SONARtrac[®] Technical Bulletin		
	Subject: Temporary Hardware Change: Transmitter terminal board – Alternate pluggable connectors	TB030	Rev:03
		Priority:6	
			Page 2 of 9

Subject: Temporary Hardware Change:
Transmitter terminal board – Alternate
pluggable connectors

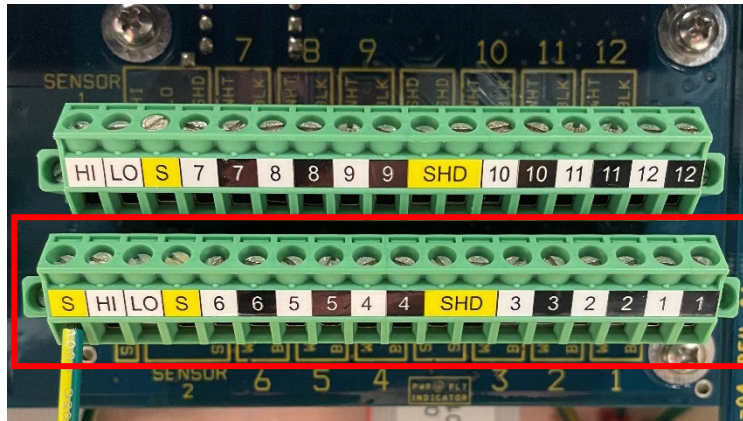
Due to product procurement delay issues, we are encountering periods in which we are temporarily unable to source the designed pluggable I/O connectors with 45° wire entry for the transmitter terminal board.

1. 18-position I/O connector for sensor head cable wire pairs 1-6 and Sensor 2 (4-20mA) Input
2. 9-position connector used for Outputs - Comm, Pulse, and Alarm
3. 17-position I/O connector for sensor head cable wire pairs 7-12 and Sensor 1 (4-20mA) Input

Procurement issue 1:

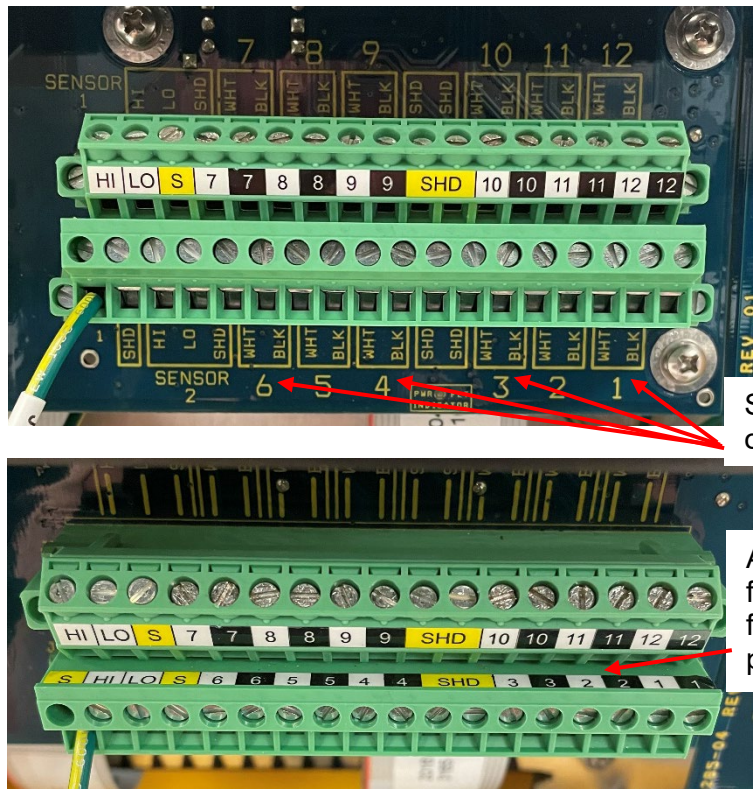
18-position pluggable Sensor I/O connector, with 45° wire entry, used for sensor head cable wire pairs 1-6 and the Sensor 2 (4-20mA) Input as is indicated in section 6.3 of the installation manual

Silk Screen labeling on terminal board

Alternate location for wiring ID sticker for the lower 18 position connector

To continue being able to ship customers transmitters a temporary alternate pluggable connector, with slightly different wire entry and screw orientation, has been identified to be used in the short term until the designed connector is again readily available.

The only change to the wiring termination instructions laid out in the Installation Manual section 6.3.2.3.1 is that 10mm of wire is recommended to be stripped rather than 8mm. The recommended torque of the terminal screws is still 4.4 to 5.3 lb_f-inch (.5 to .6 Nm).

Although the terminal board itself is silkscreened to indicate the proper wire pair and color termination points the sticker affixed to the pluggable connector indicating same wire pair and color termination points may not be as easily viewed as it presently is with the intended connector design. As a result, the person performing the installation and wiring of new transmitters may find it easier to terminate wire pairs 1-6, prior to terminating wire pairs 7-12. (The shield wire in cable can be terminated in any of the four available locations between channels 3 & 4 or 9 & 10)

Procurement issue 2:

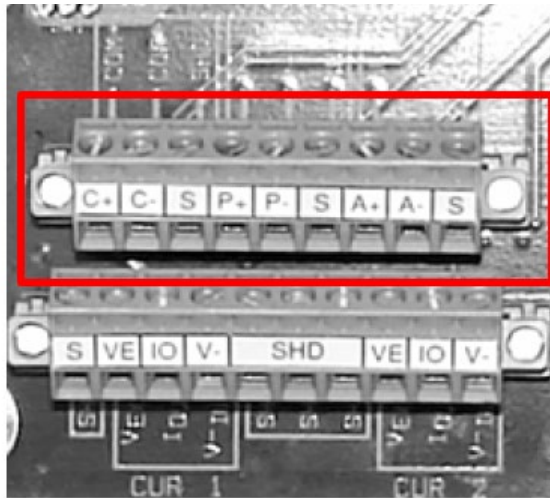
9-position pluggable, with 45° wire entry, used for Outputs - COMM, PULSE, and ALARM as referenced in installation manual section 6.3.2.1

To continue being able to ship customers transmitters a temporary alternate pluggable connector, with slightly different wire entry and screw orientation, has been identified to be used in the short term until the designed connector is again readily available.

The wire entry is perpendicular to the board rather than at a 45° angle as in the designed connector. Unfortunately, the terminal screws are from top down making accessibility, when connector is plugged in, likely impossible due to the proximity of the chassis fixture for the keypad and display. The alternative 9-position pluggable connector will likely need to be removed from the circuit board mate to terminate wires to it and then reinserted into the circuit board mate.

As we find that few customers utilize the COMM, PULSE and ALARM outputs CiDRA Engineering has determined that the alternate connector will be acceptable in the short term. For customers known to use any of these outputs (MODBUS Comms specifically) an effort will be made to continue using the limited inventory available of 45° angle connectors on those transmitters.

Procurement issue 3:

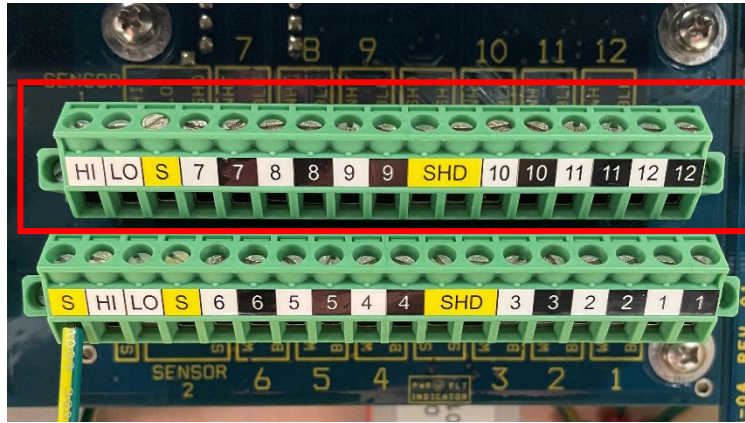
17-position pluggable Sensor I/O connector, with 45° wire entry, used for sensor head cable wire pairs 7-12 and the Sensor 1 (4-20mA) Input as indicated in section 6.3 of the installation manual.

To continue being able to ship customers transmitters a temporary alternate pluggable connector, with slightly different wire entry and screw orientation, has been identified to be used in the short term until the designed connector is again readily available.

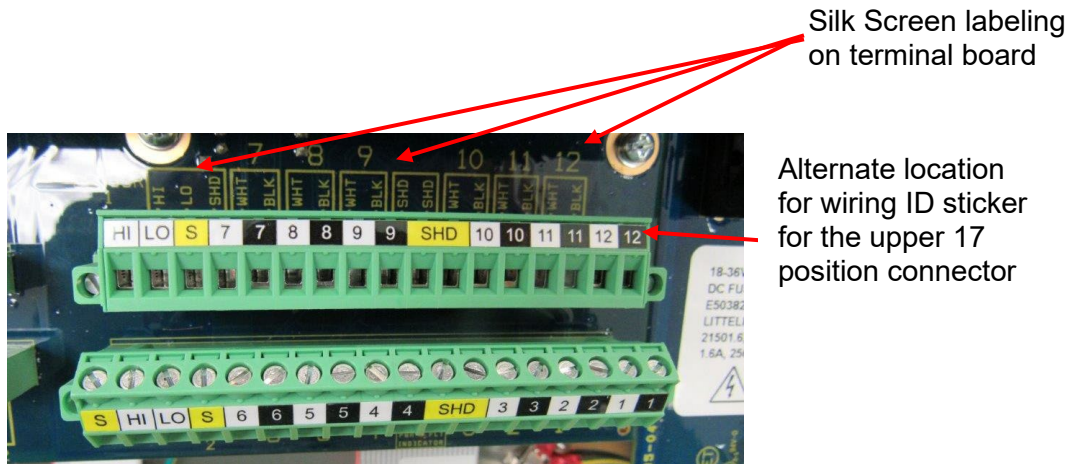
The alternative connector wire entry is perpendicular to the board rather than at a 45° angle as in the designed connector. Unfortunately, the terminal screws are from top down making accessibility, when connector is plugged in, likely impossible due to the proximity of the chassis fixture for the keypad and display. The alternative 17-position pluggable connector will likely need to be removed from the circuit board mate to terminate wires to it and then reinserted into the circuit board mate. As a result, the person performing the installation and wiring of new transmitters may find it easier to terminate wire pairs 1-6, prior to terminating wire pairs 7-12, as well as the Sensor 1 (4-20mA) Input if it is being used. The installer will then reinsert the 17-position pluggable connector back into the circuit board mate. (The shield wire in cable can be terminated in any of the four available locations between channels 3 & 4 or 9 & 10).

The recommended wire stripping length for the alternative connector will be 7mm. The torque applied to the screws will be as outlined in the installation manual 4.4 to 5.3 lb_f-inch (.5 to .6 Nm). The torque applied to the two side screws, for securing the connector to the base will be 3.5 to 4.4 lb_f-inch (.4 to .5 Nm).
